# Elephant Mt. WMA- ADA Evaluation

Accessibility Evaluation

Inspection Date: 06/20/2022

Report Date: 01/18/2024

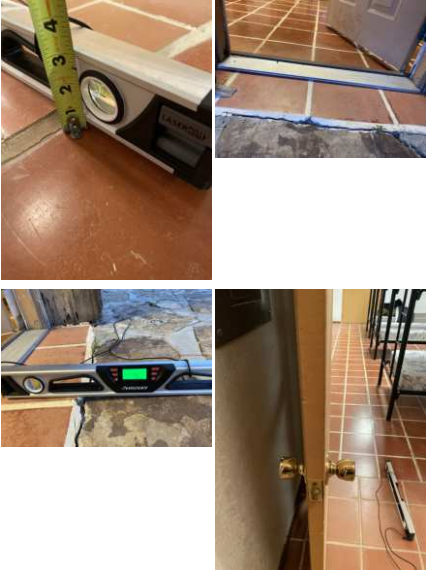
34	Structures on Property (Public) : Education Center (Interior) - Restroom #2, Near Rear Exit (Unisex)	There are not enough accessible lavatories. Where lavatories are provided, at least one shall be accessible and shall not be located in a toilet compartment.	The lavatory and accessories are not compliant.	Review lavatory componets to make accessible. <a href="https://www.access-board.gov/ada/#ada-213_3_4">https://www.access-board.gov/ada/#ada-213_3_4</a> <a href="https://www.access-board.gov/ada/#ada-606">https://www.access-board.gov/ada/#ada-606</a>	2012 TAS Section: 213.3.4 2010 ADAS Section: 213.3.4 2015 ABAAS Section: F213.3.4

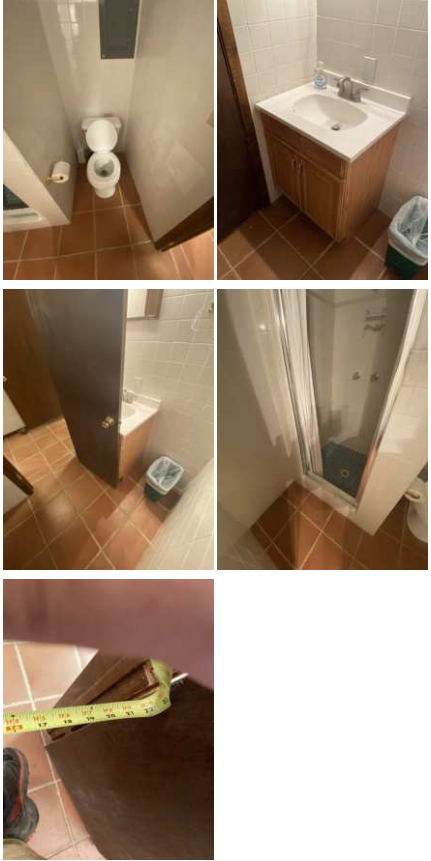
Finding Number	Area Description	Finding	As Built	Recommendation	Citation	Photos	Figure
44	Structures on Property (Public) : Bunk House (Interior) - Entrance/Exit Doors	The door operating hardware requires tight grasping, pinching or twisting of the wrist to operate. Hand-activated hardware, handles, pulls, latches, locks, and other operating devices on accessible elements shall have a shape that is easy to grasp with one hand and does not require tight grasping, pinching or twisting of the wrist to operate.	Door hardware and locking mechanism is not compliant. All doors in bunk house have non compliant hardware.	Review door and threshold componets to make accessible <a href="https://www.access-board.gov/ada/#ada-404">https://www.access-board.gov/ada/#ada-404</a>	2012 TAS Section: 309.4 2010 ADAS Section: 309.4 2015 ABAAS Section: 309.4		
45	Structures on Property (Public) : Bunk House (Interior) - Restroom #1 (Unisex)	The restroom is not nearly compliant. The restroom does not have the required minimum clear floor space or maneuvering clearances for the toilet. The restroom does not have the required minimum clear floor space or maneuvering clearances for the lavatory. The entry door does not contain the required minimum maneuvering spaces on the pull/push sides. The entry door encroach into the required clear floor space for fixtures. Grab bars are missing and/or incorrectly installed. Accessories, such as toilet seat covers, paper towel holders, garbage cans, hand dryers, and mirrors are either too high or without clear floor space or both. The restroom contain floor level changes greater than a 1/2 inch of the floor drains and is slope (XX) - (XX), the shower is too small and missing numerous accessible elements.	This restroom requires a number of componets to gain compliance.	<a href="https://www.access-board.gov/ada/#ada-213_2">https://www.access-board.gov/ada/#ada-213_2</a> Review restrooms componets to make accessible. <a href="https://www.access-board.gov/ada/#ada-603">https://www.access-board.gov/ada/#ada-603</a>	2012 TAS Section: 213.2 2010 ADAS Section: 213.2 2015 ABAAS Section: F213.2

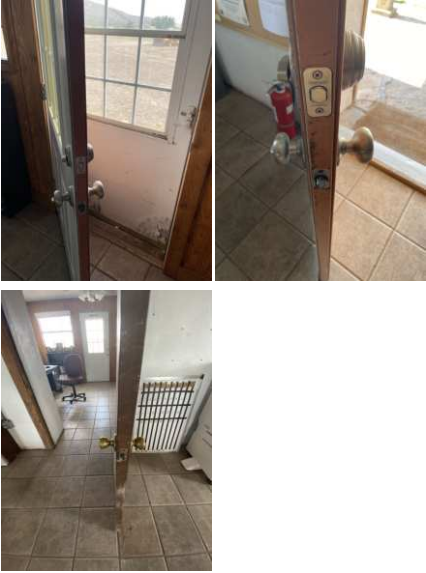
64	Structures on Property (Public) : Office (Exterior) - Pathway to Office	The building entrance is not located on an accessible route. When a building, or portion of a building, is required to be accessible, an accessible route of travel shall be provided to all portions of the building, to accessible building entrances and between the building and the public way. At least one accessible route within the boundary of the site must be provided from public transportation stops, accessible parking and accessible passenger loading zones and public streets or sidewalks to the accessible building entrance they serve. The accessible route shall, to the maximum extent feasible, coincide with the route for the general public. At least one accessible route shall connect accessible buildings, facilities, elements and spaces that are on the same site. At least one accessible route shall connect accessible building or facility entrances with all accessible spaces and elements.	Due to terrain type, lack of accessible pathway, stairs, and door hardware or thresholds there is no way to gain access to building. This building is not accessible	<a href="https://www.access-board.gov/ada/#ada-206_2_1">https://www.access-board.gov/ada/#ada-206_2_1</a>	2012 TAS Section: 206.2.1  2010 ADAS Section: 206.2.1  2015 ABAAS Section: F206.2.1
